Addendum No. 1
100% Construction Documents

June 10, 2025

Project:
FSU Parking Garage 1 Remodeling

ALW Project No. 19370.42

Sheet No.:
LS1.1

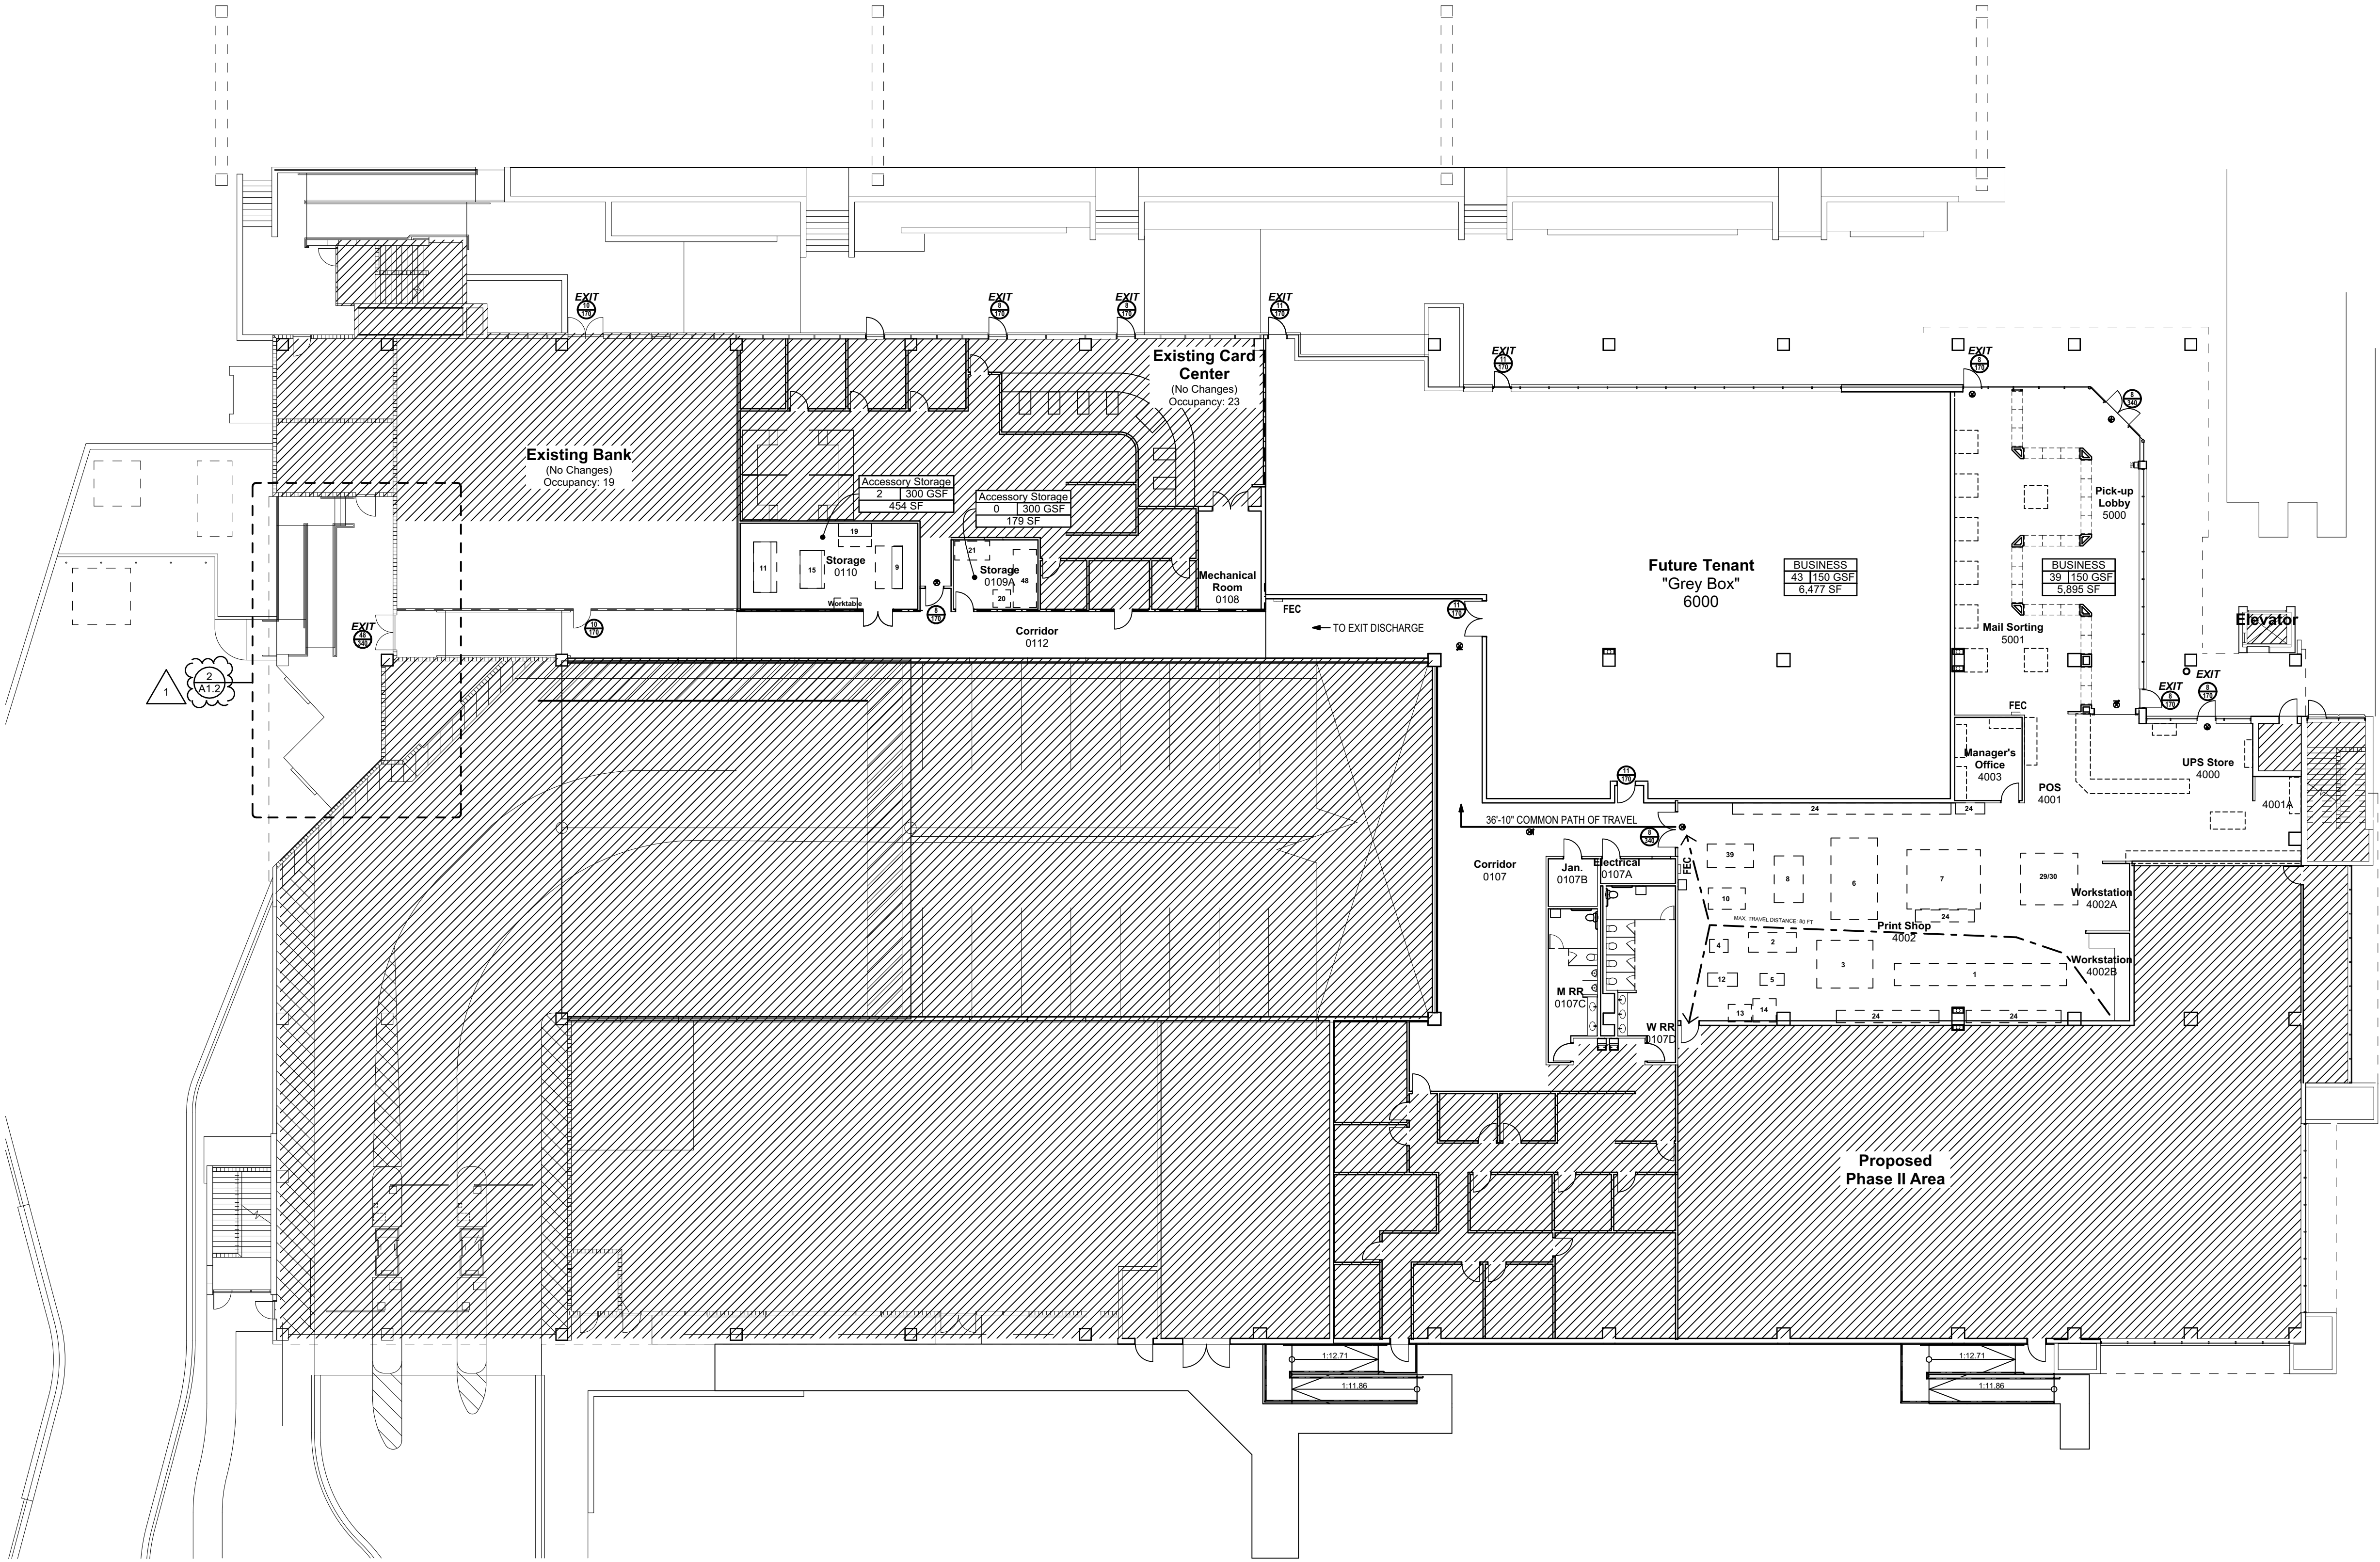
- **Revise** detail marker to reference enlarged plan 2 on sheet A1.2
This revision is in response to BCA's Plans Compliance Review.

1 1st Floor Demolition Plan
3/32" = 1'-0"

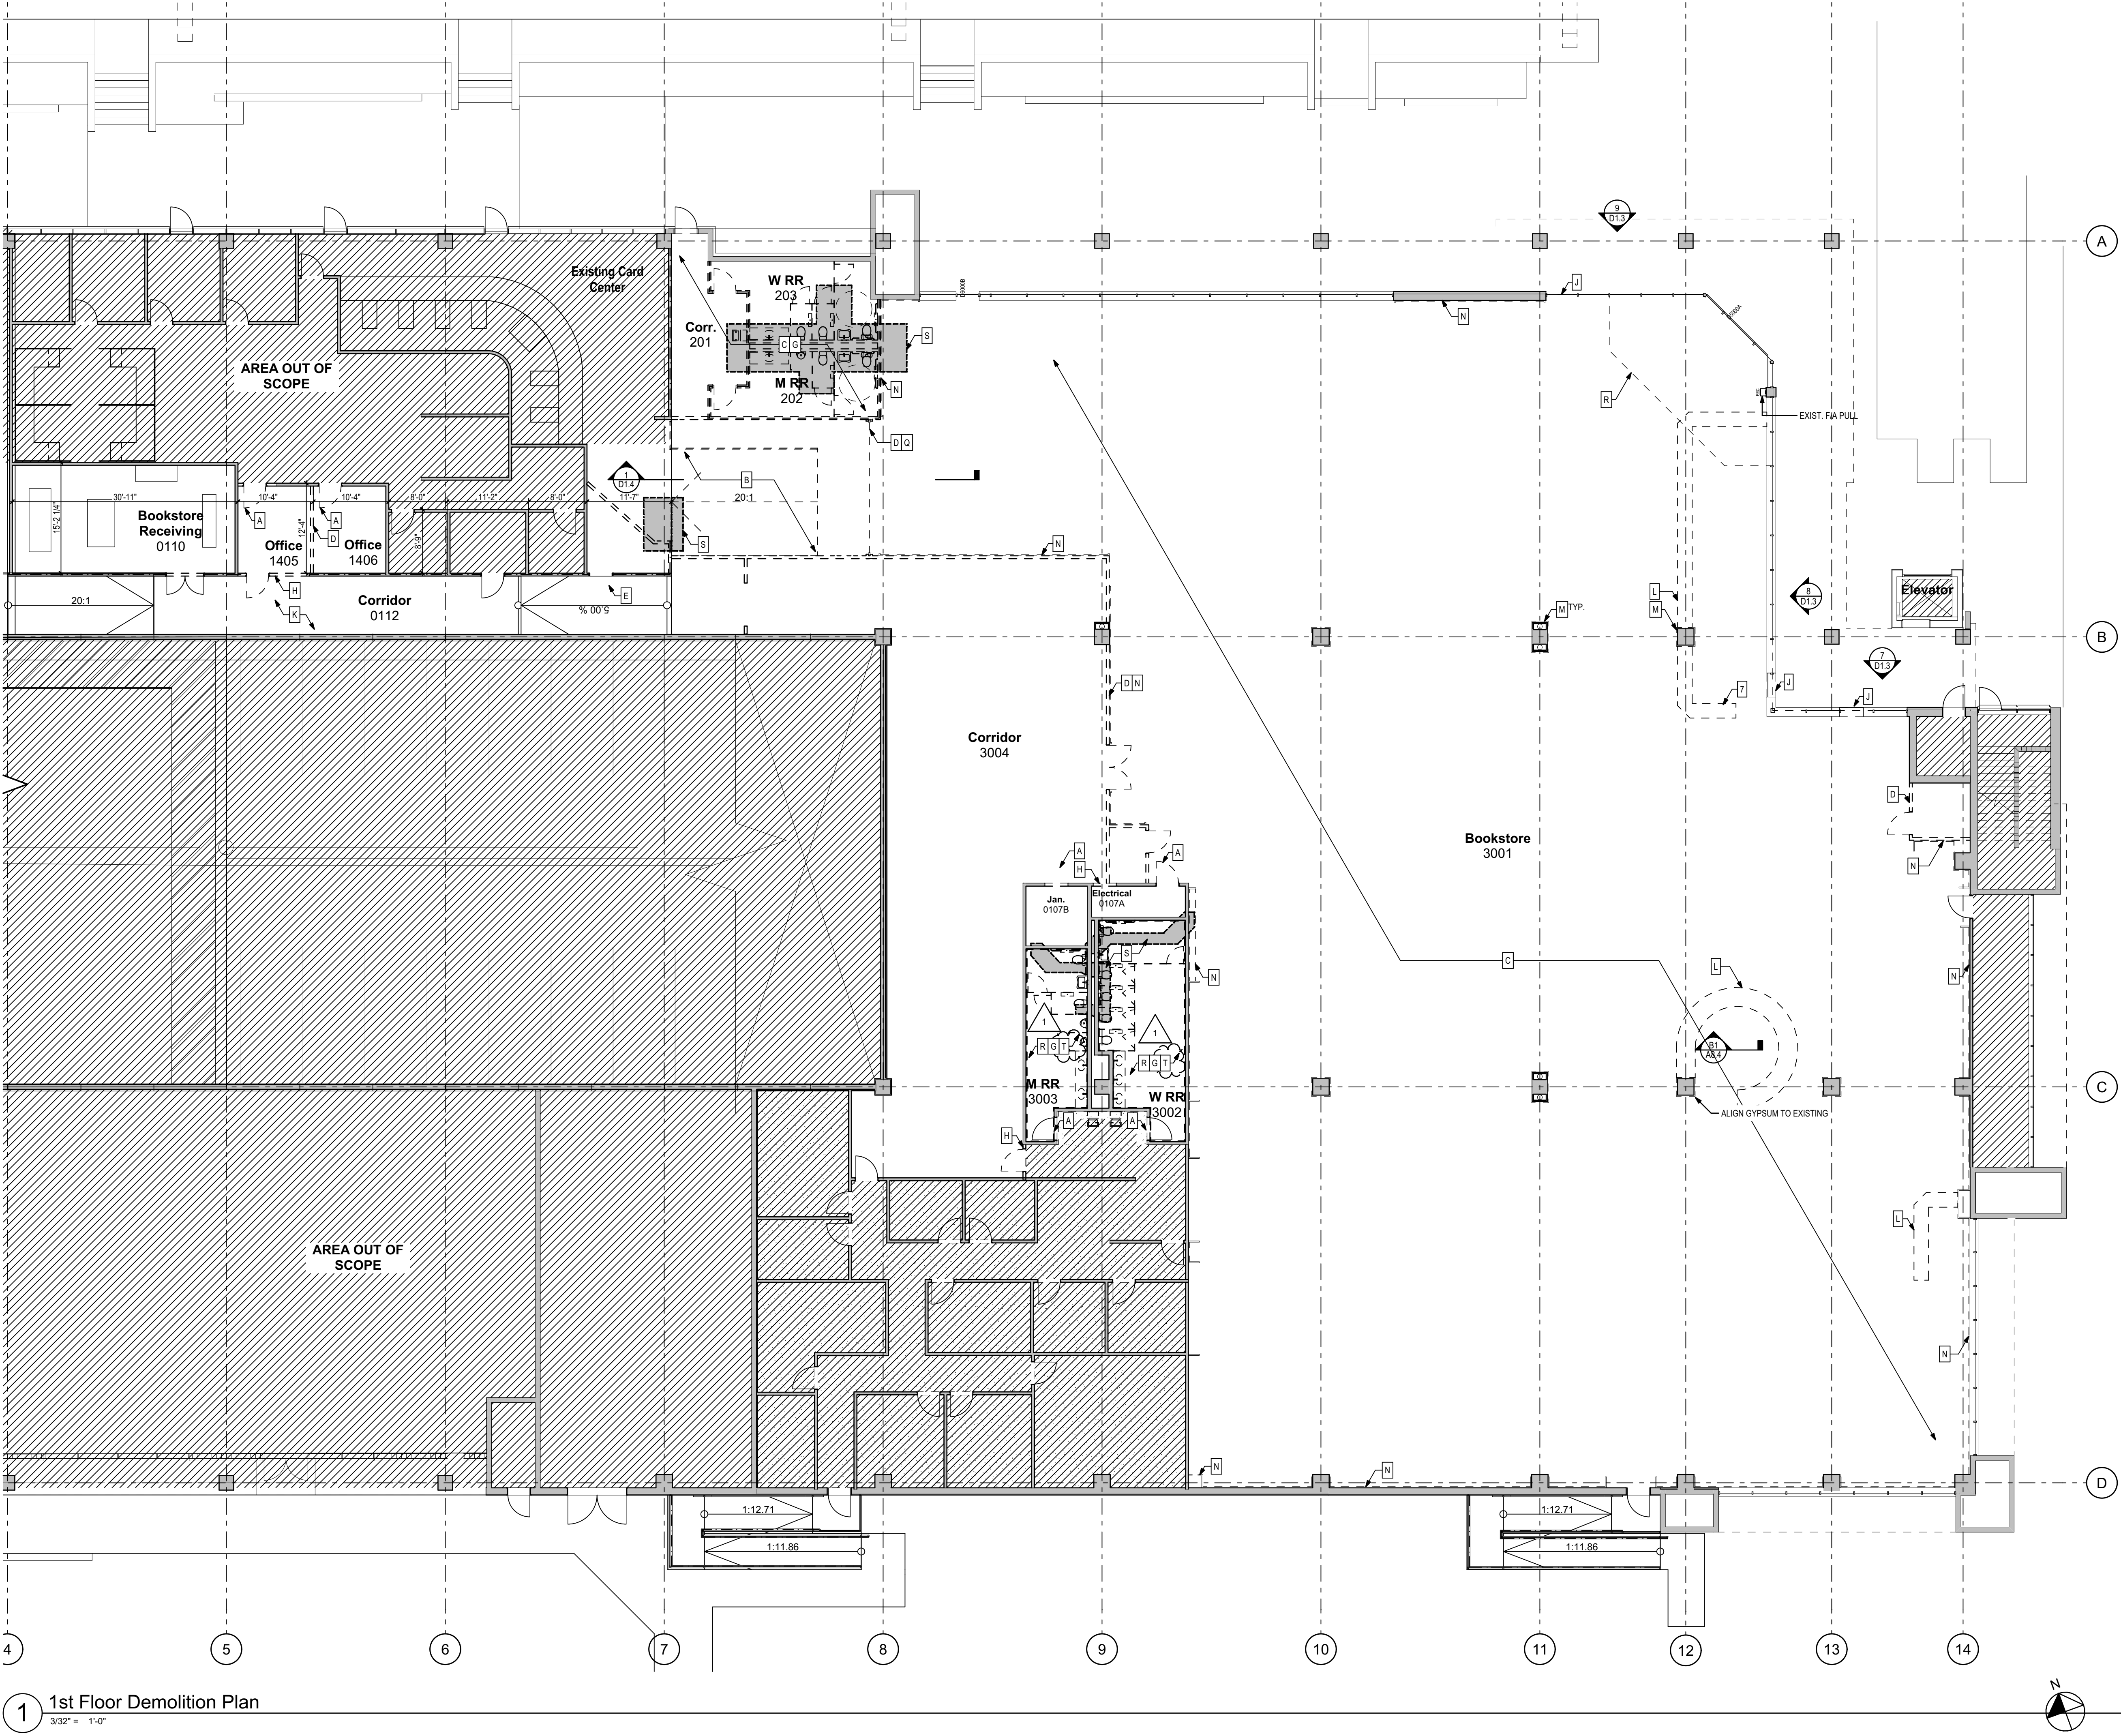
- **Add** removal of gypsum wall board in Restrooms 3002 & 3003 (Demolition Note T).

- S DEMOLISH PORTION OF CONCRETE SLAB FOR NEW PLUMBING TRENCH. COORDINATE FINAL LOCATION AND SIZE WITH PLUMBING CONTRACTORS.
 - T REMOVE GYPSUM ON INTERIOR FACE OF RESTROOM WALLS TO PREPARE FOR NEW TILE BACKER BOARD. PROTECT EXISTING FRAMING.

Sheet No.:
D1.1

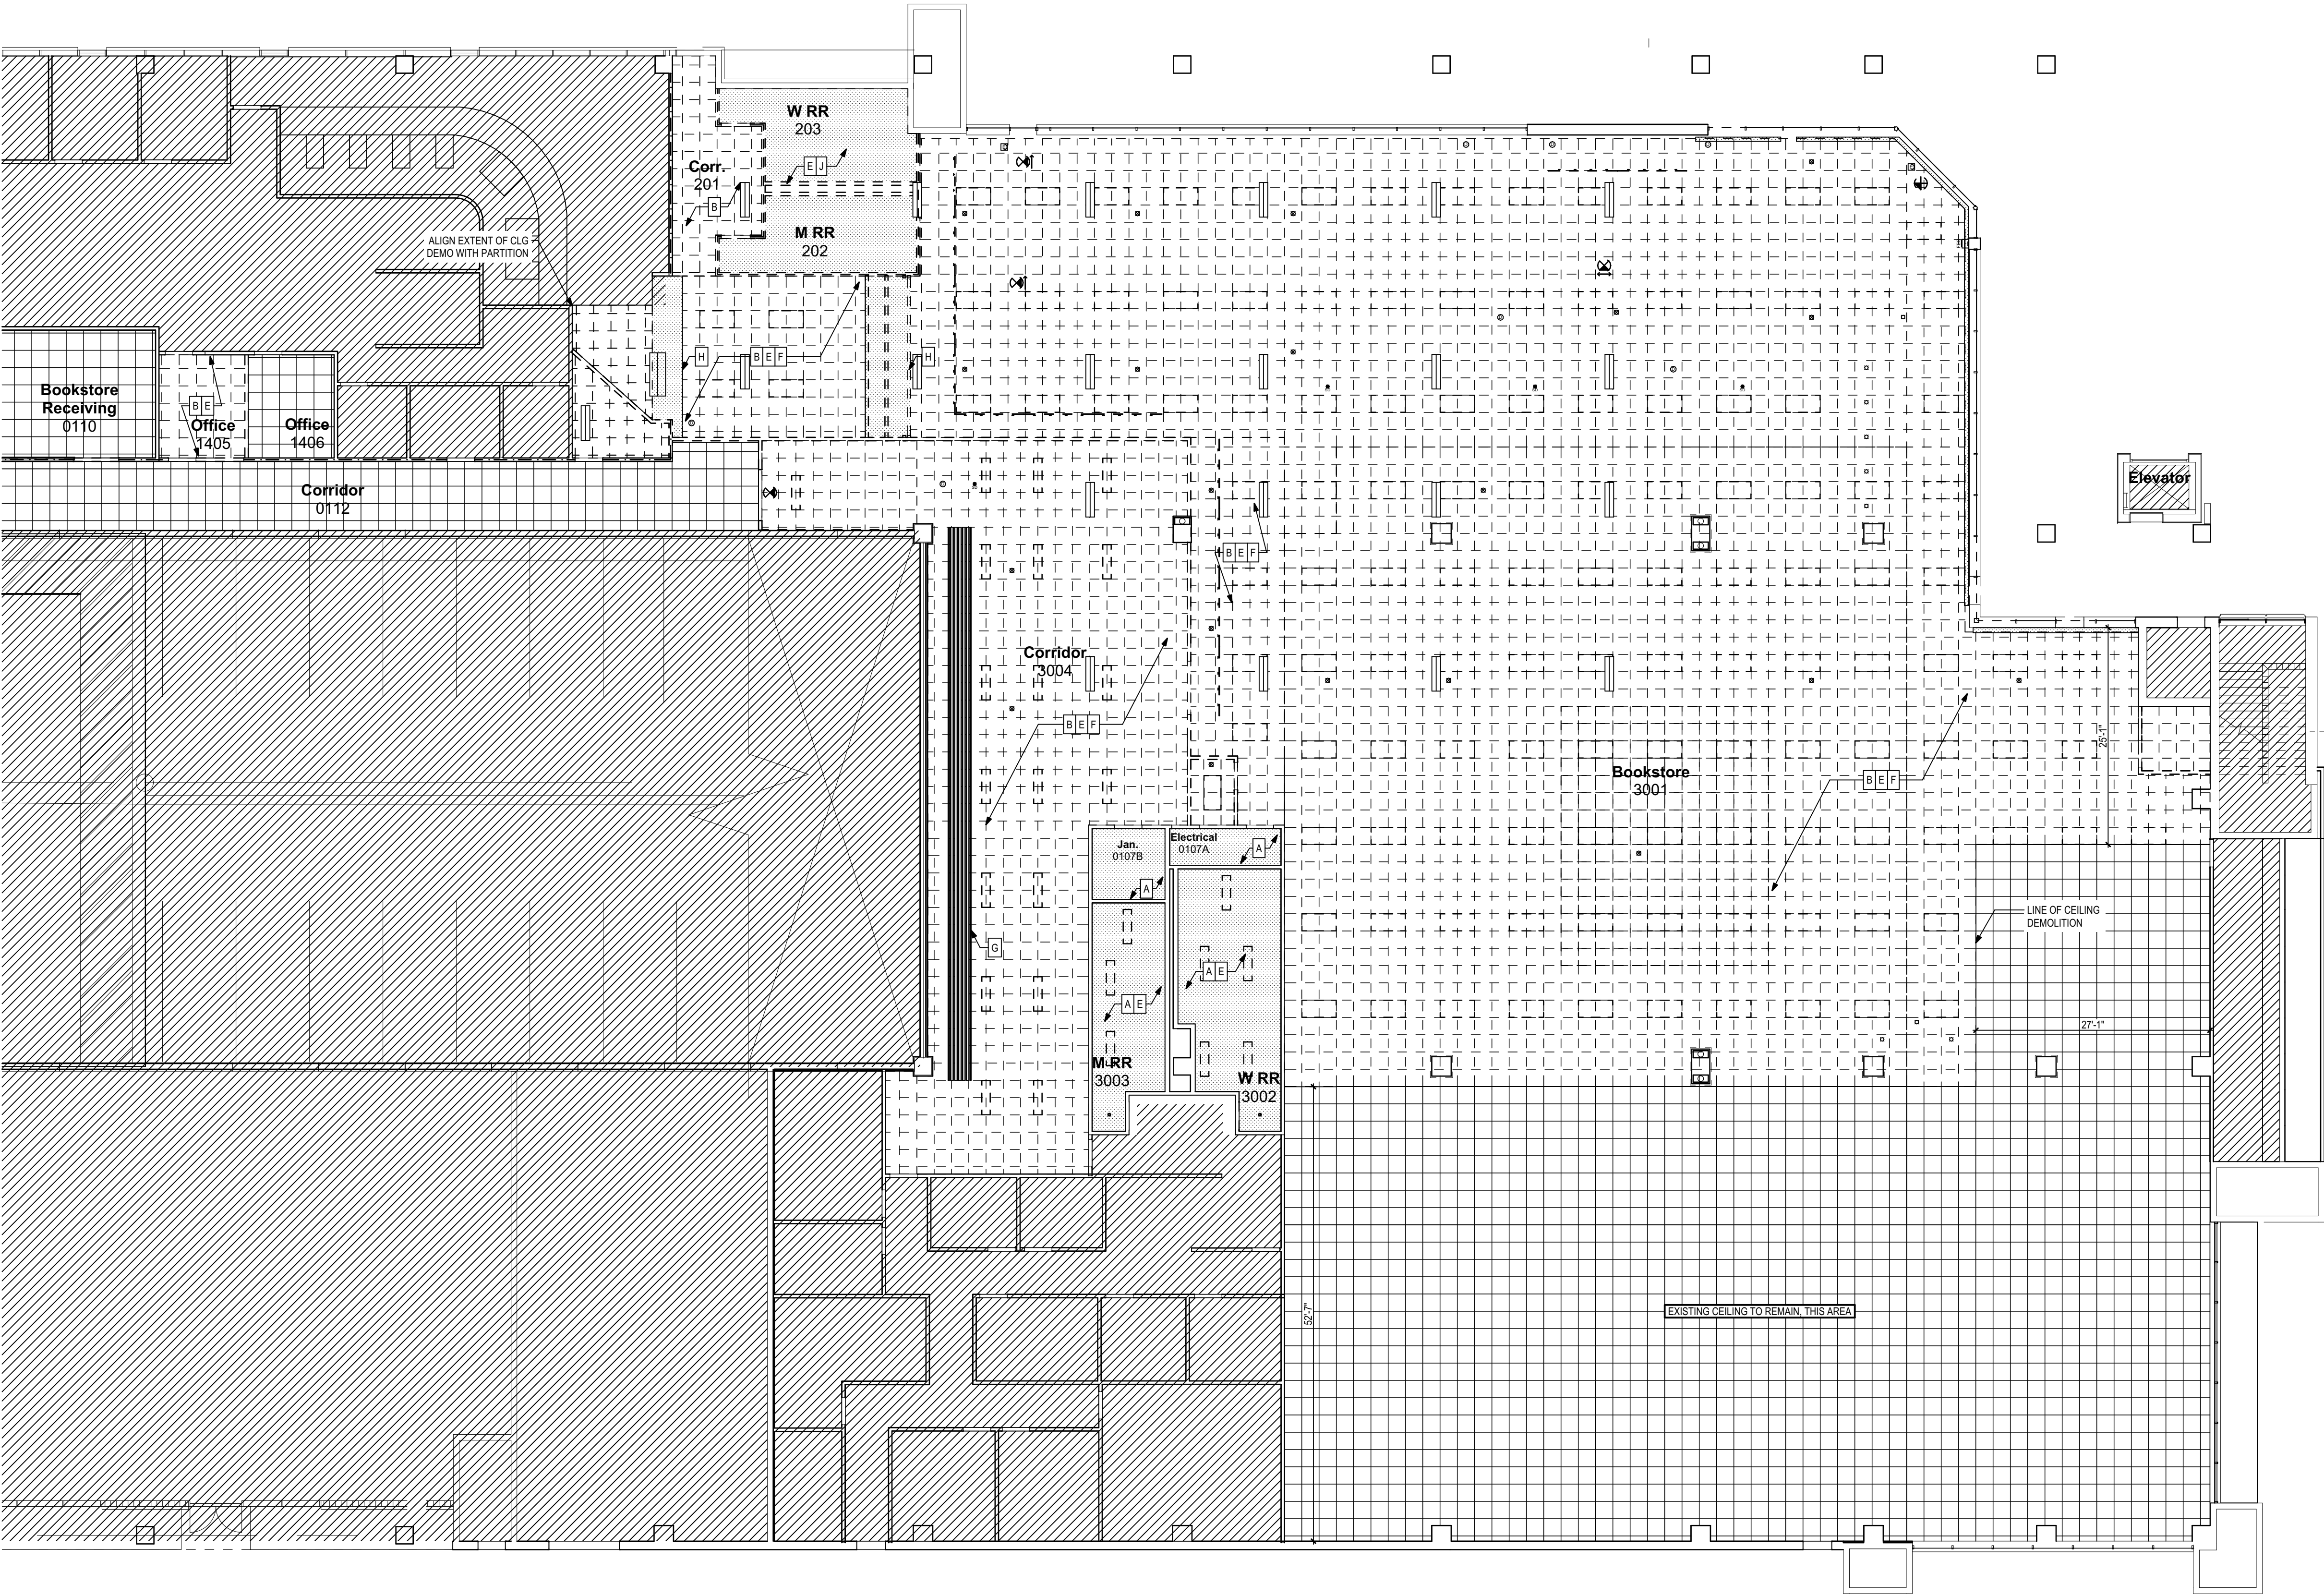
- **Delete** note to salvage existing light fixtures (Demolition Note E).
